Marion County

Development Review Committee

Meeting Minutes

Monday, June 1, 2026

- 9.1. Waiver clarification from 11/3/25 DRC Meeting Motion made for Item 6.2. Champion Homes #000610-2026 regarding Buffer request.

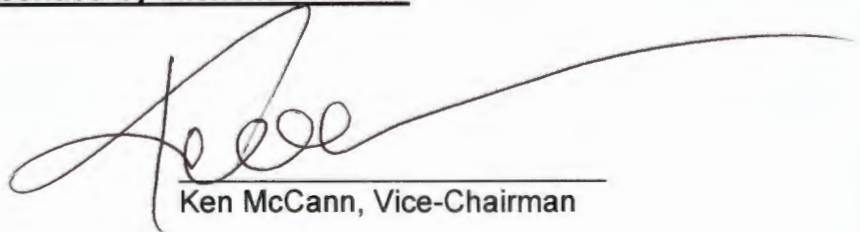
The DRC needs to make a motion to clarify the conditions of the prior order.

Motion by Steven Cohoon to clarify, seconded by Tony Cunningham
